Simplified classification in the State Diagram II v121

This baseline is the follow up to [yesebootd_01_1116_simpleclass.pdf](#). Aims are as follows:

OPTION 1: Replace the classification SD on page 97 as follows:

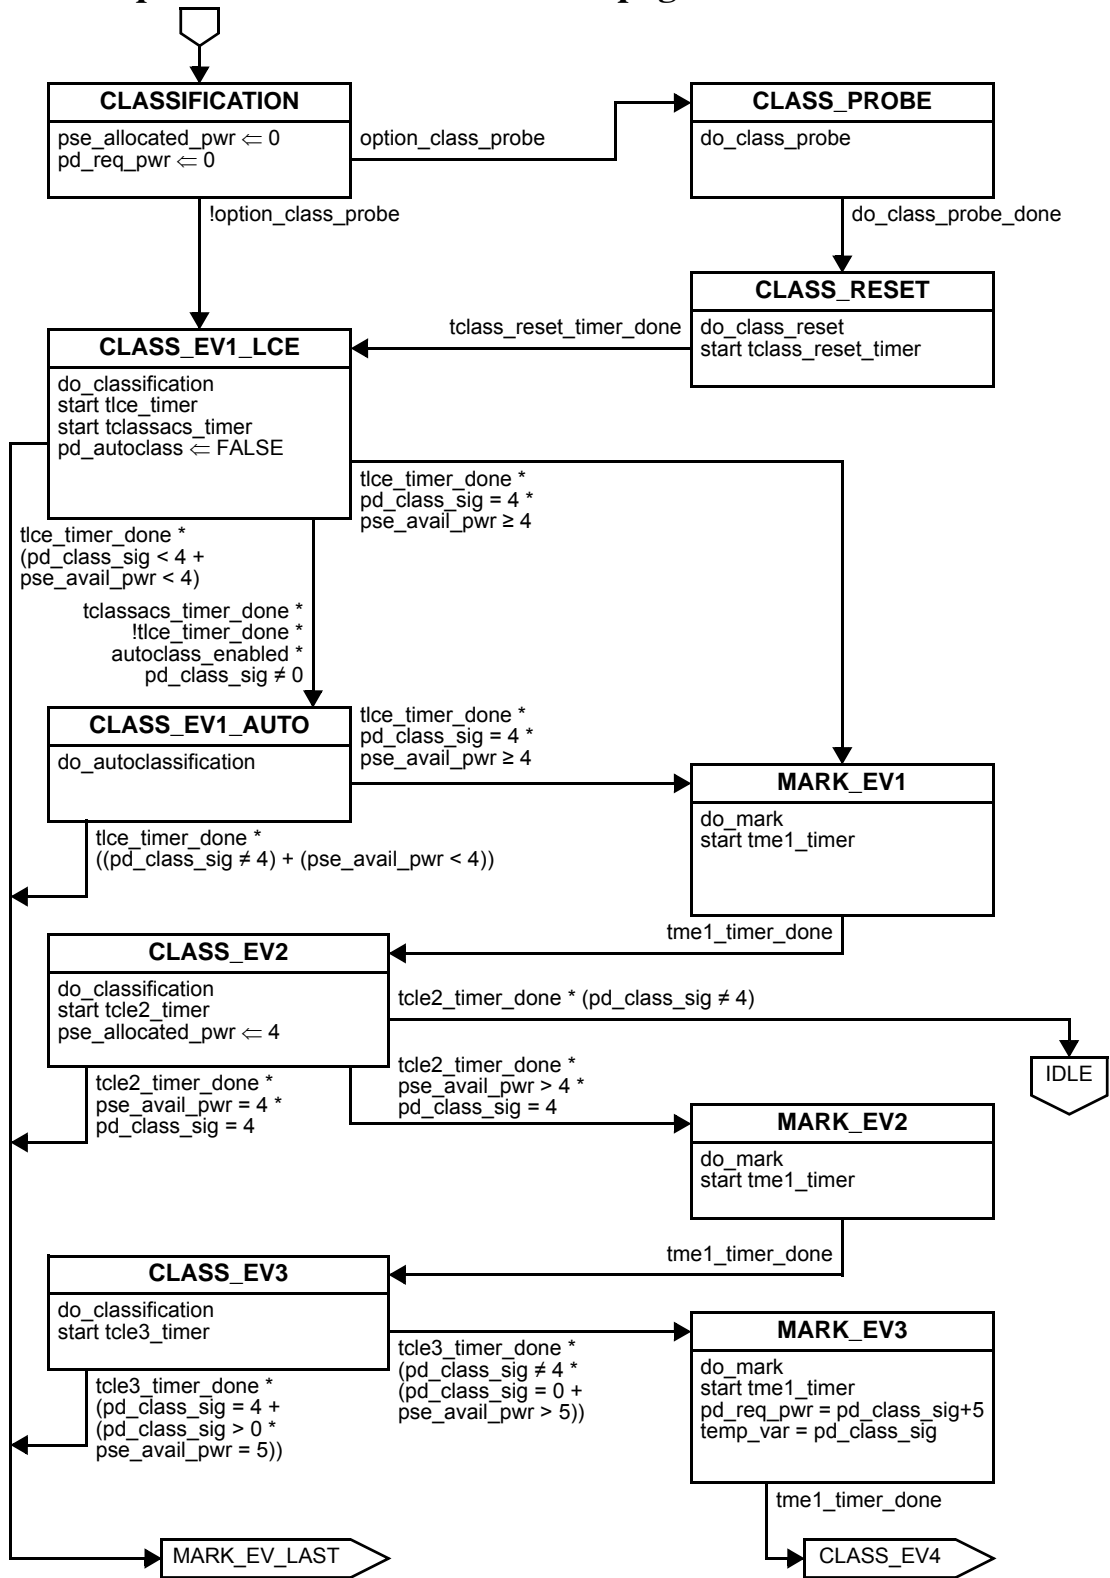
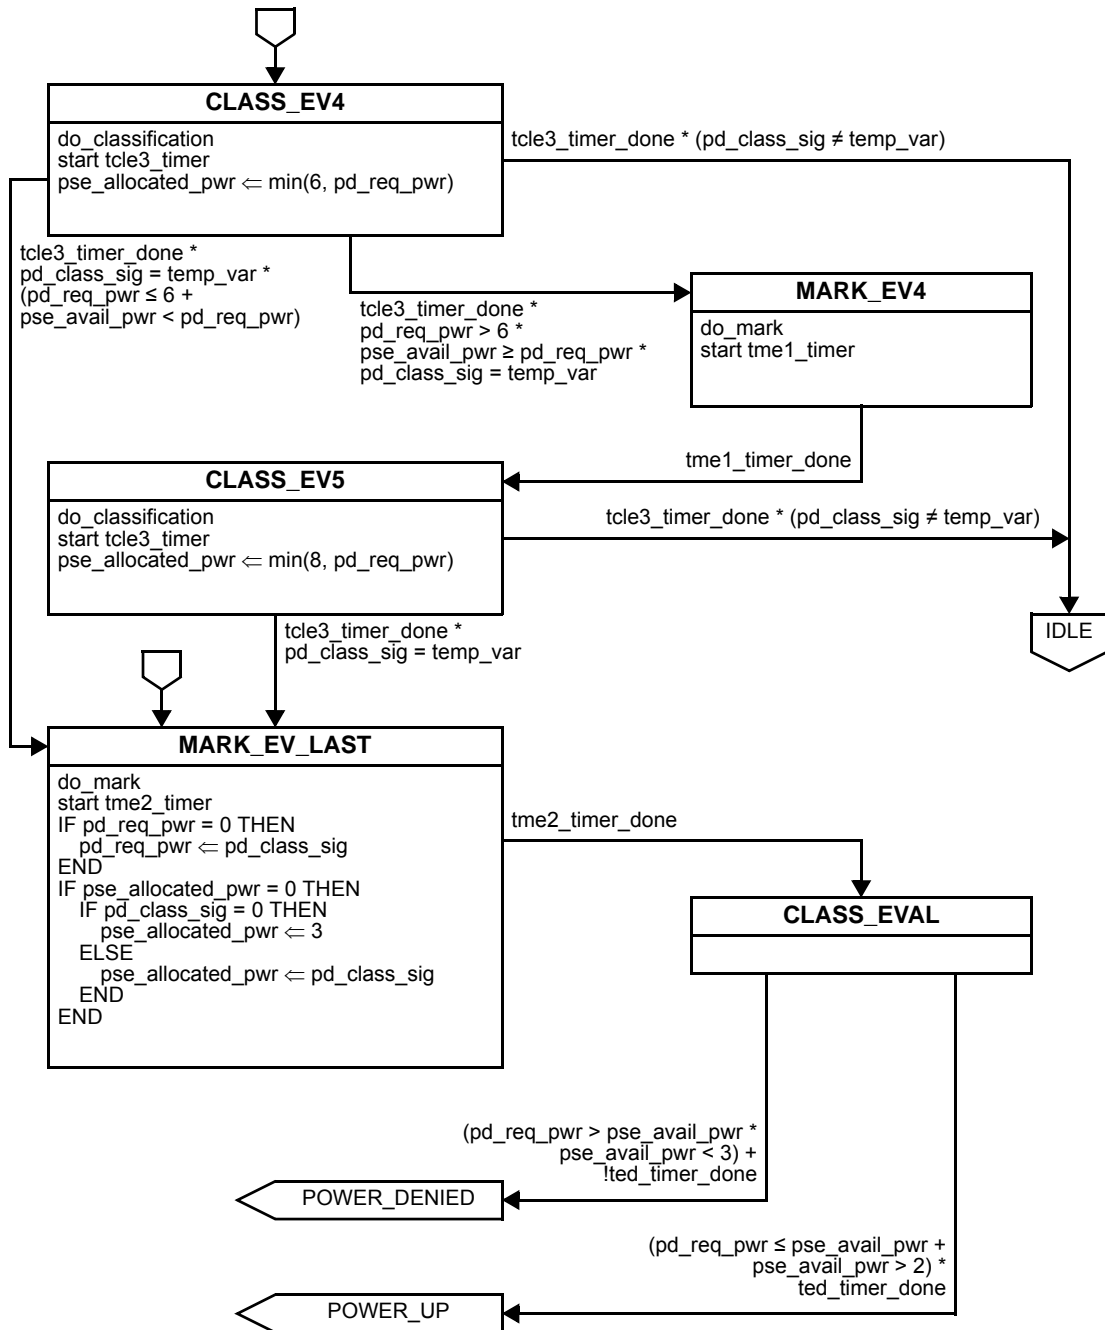
Change the arcs going from `DETECT_EVAL` and `CXN_CHK_DETECT_EVAL` to `CLASS_EV1_LCE` to go to `CLASSIFICATION` in stead.

Remove the `CLASS_EVAL` state from page 95.

OPTION 1

With option 1, if the PSE has `pse_avail_pwr=4` it will stop after 2 class events and will not know the PDs requested Class for sure. The `option_class_probe` (if enabled) can still find out the requested class, but that would cost a redundant class reset for this particular case.

OPTION 2: Replace the classification SD on page 97 as follows:

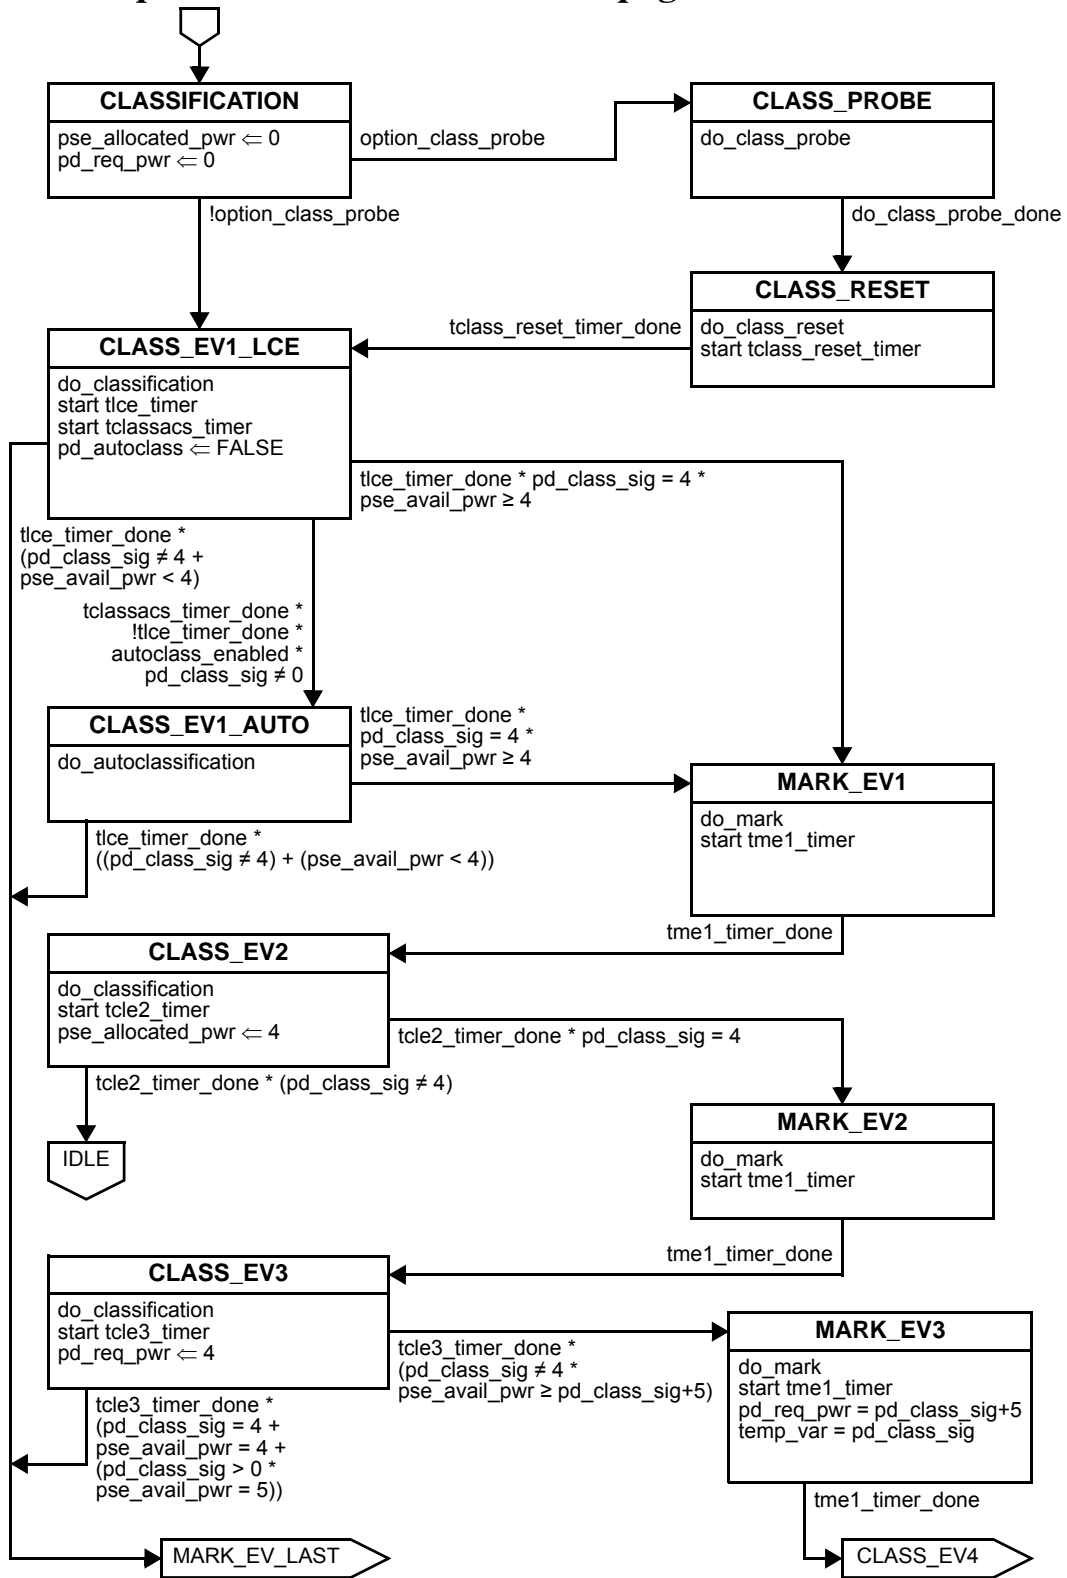
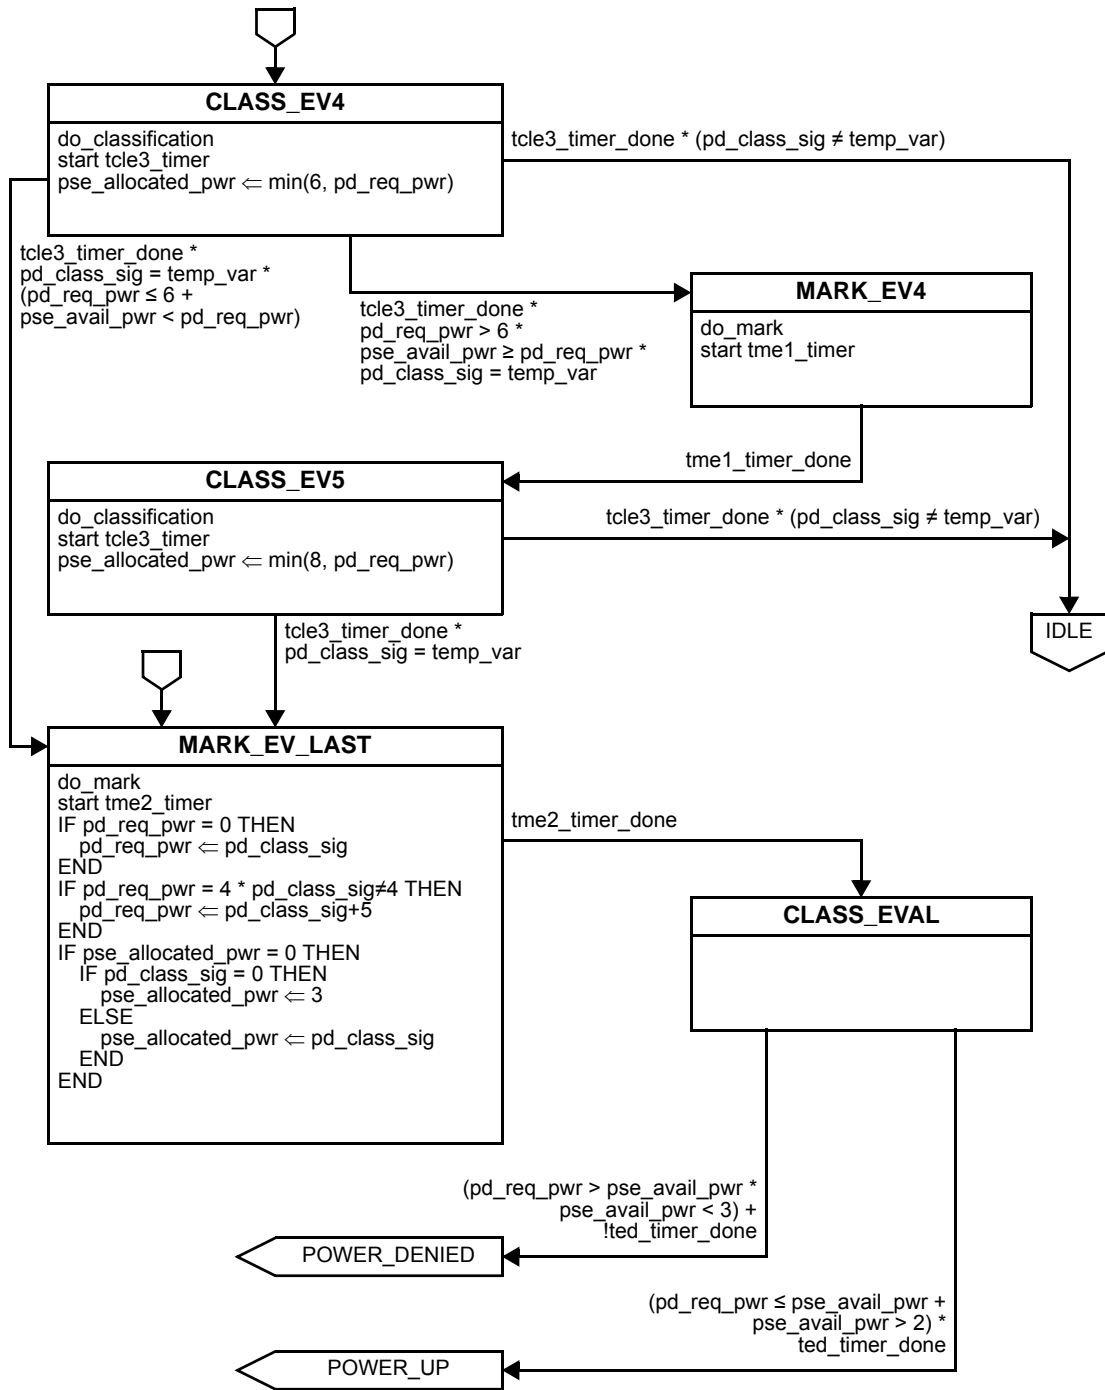
OPTION 2

With option 2, the PSE will always produce at least 3 class events if it has `pse_avail_pwr=4` to determine the requested Class of the PD.
